SUBJECT: Dairyland Power Cooperative
La Crosse Boiling Water Reactor (LACBWR)
Possession-Only License DPR-45
LACBWR Decommissioning Plan and Post-Shutdown Decommissioning Activities
Report (D-Plan/PSDAR) Revision – March 2014

**LACBWR DECOMMISSIONING PLAN
AND
POST-SHUTDOWN DECOMMISSIONING ACTIVITIES REPORT**

REVISED MARCH 2014

DESCRIPTION OF CHANGES

**FIGURE 2.1
LACBWR SCHEDULE**

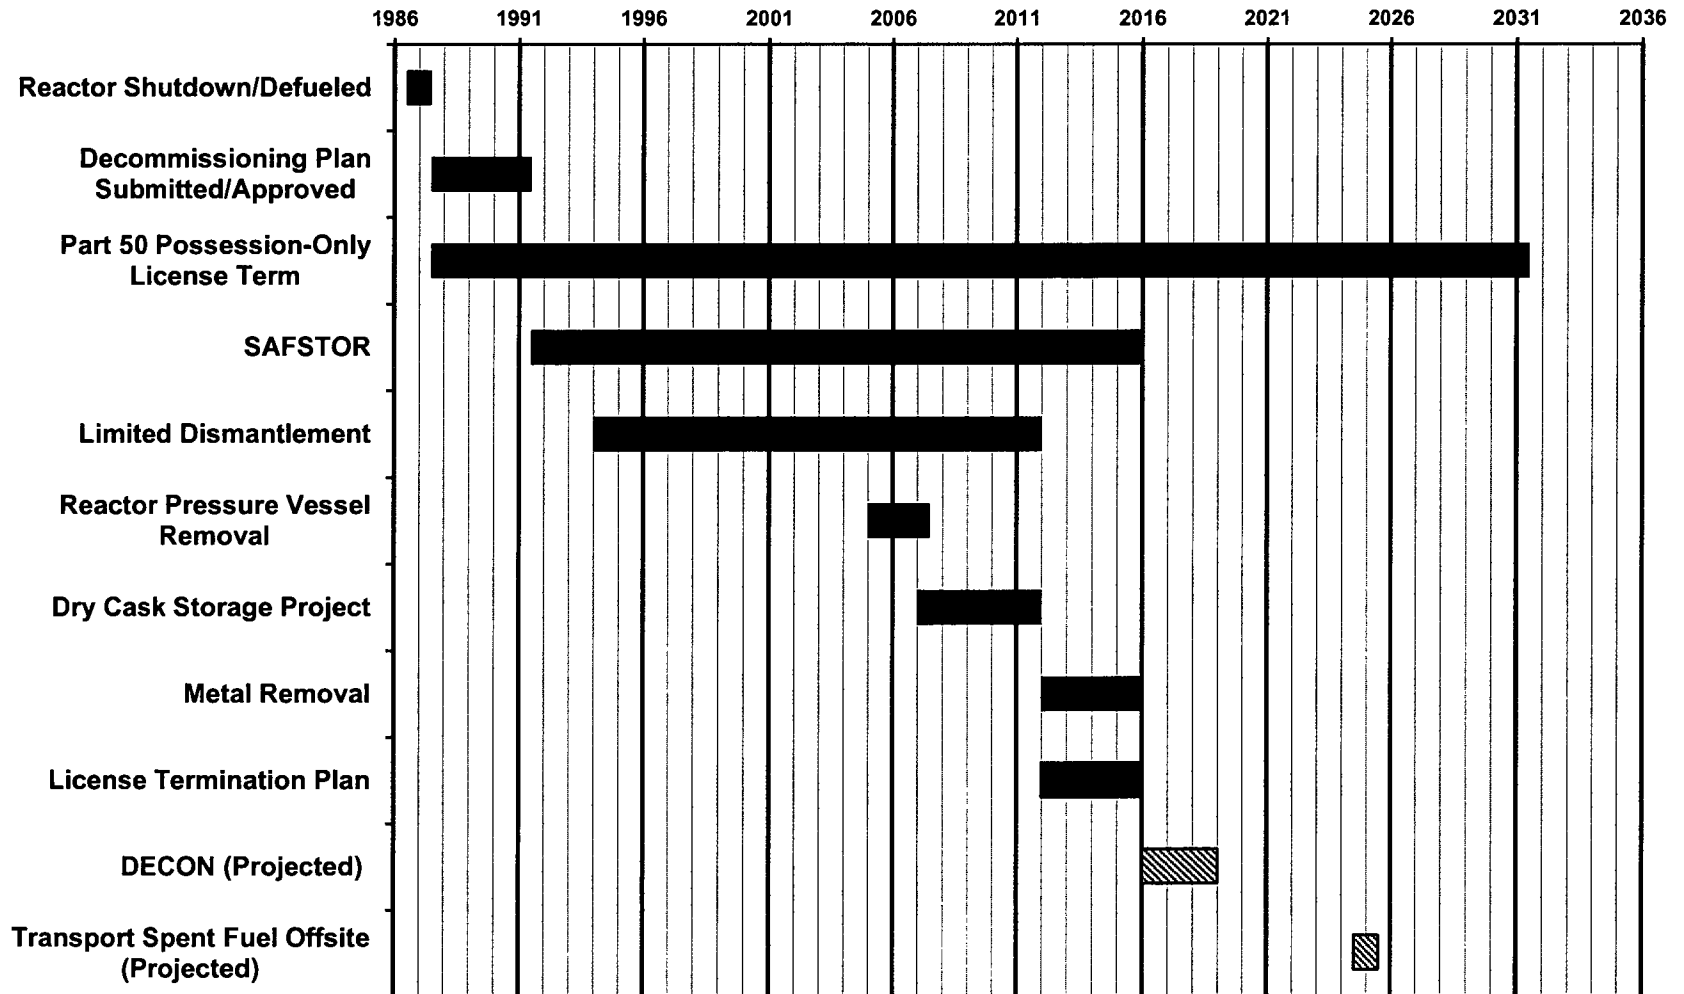
In 2007, DPC began efforts to place an ISFSI on site by commencing the Dry Cask Storage Project. An on-site ISFSI was the available option that provided flexibility for license termination of the LACBWR facility. With respect to the federal repository option, a marker for transport of spent fuel offsite has also been added to Figure 2.1 as best available information can provide.

DPC's review and analysis found that the Nuclear Decommissioning Trust (NDT) was sufficiently funded to allow dismantlement to begin in 2012 immediately after spent fuel removal was completed. Costs of the metal removal project will be funded from the NDT. DPC's approved strategy requires continuing evaluation of the costs of the decommissioning activity as it progresses. During this time the LTP will be formulated and will include an updated site-specific estimate of remaining decommissioning costs. DPC's decommissioning strategy for LACBWR with accelerated systems removal provides flexibility in that provisions are afforded to evaluate the costs and benefits of alternative methodologies for concrete removal, and delay LTP implementation if necessary to assure adequate NDT funds are available for the final decommissioning process. Figure 2.1 depicts the revised schedule.
